MYERS AT CODY SUBDIVISION

APPLICATION NUMBER 15 DATE January 17, 2008

REQUEST Subdivision

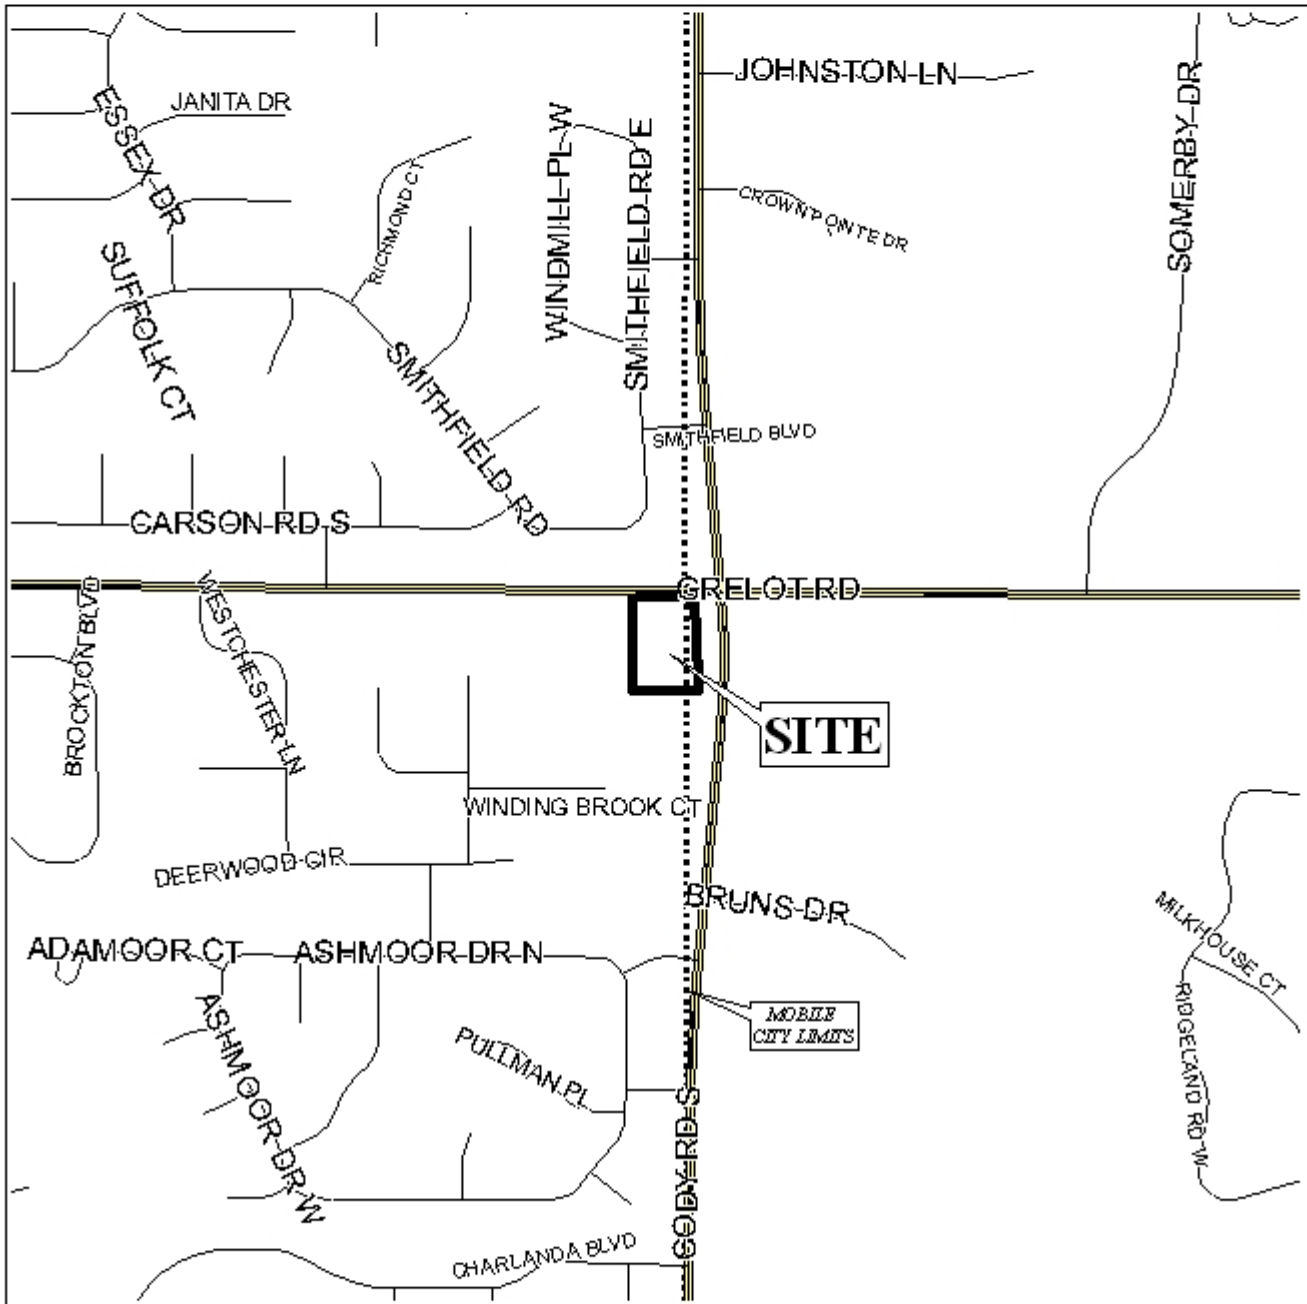
The plat illustrates the proposed 2-lot, 2.1± acres subdivision which is located on the Southwest corner of Cody Road South and Grelot Road. The subdivision is served by public water and sanitary sewer.

The site fronts Cody Road South and Grelot Road, both planned major streets, which have existing right-of-ways illustrated as variable; the Major Street Plan requires a minimum 100-foot right-of-way. Therefore, the dedication of sufficient right-of-ways to provide 50-feet from the centerlines of Cody Road South and Grelot Road as well as the appropriate radius should be required. The 25-foot minimum building setback line should be revised to reflect any required dedication.

As a means of access management, the placement of a note on the Final Plat stating that Lot 1 is limited to the existing curb cuts to Cody Road South and Grelot Road should be required. Additionally, Lot 2 illustrates approximately 120-feet along Cody Road South should be limited to one curb cut, with the size, design and location to be approved by County Engineering and conform to AASHTO standards.

The site is located in the county; therefore, a note should be placed on the final plat stating that any lots developed commercially and adjoining residentially developed property must provide a buffer, in compliance with Section V.A.7. of the Subdivision Regulations. While the site is located in the county, compliance with the City of Mobile storm water and flood control ordinances will be required. A letter from a licensed engineer certifying compliance with the City's storm water and flood control ordinances should be submitted to the Mobile County

- 1) the dedication of adequate right-of-way to provide 50-feet from the centerlines of Cody Road South and Grelot Road, and revision of the 25-foot minimum building setback line to reflect dedication;

- 2) the placement of a note on the final plat stating that Lot 1 is limited to the existing curb cuts to Cody Road South and Grelot Road;
- 3) the placement of a note on the final plat stating that Lot 2 is limited to one curb cut to Cody Road South, with the size, design and location to approved by County Engineering and conform to AASHTO standards;

- 4) the dedication of appropriate radius at the intersection of Cody Road South and Grelot Road;
- 5) placement of a note on the plat / site plan stating that the site must be developed in compliance with all local, state and Federal regulations regarding endangered, threatened or otherwise protected species;

- 7) labeling of each lot with its size in square feet; and
- 8) the placement of a note on the final plat stating that any property that is developed commercially and adjoins residentially developed property shall provide a buffer, in compliance with Section V.A.7. of the Subdivision Regulations.
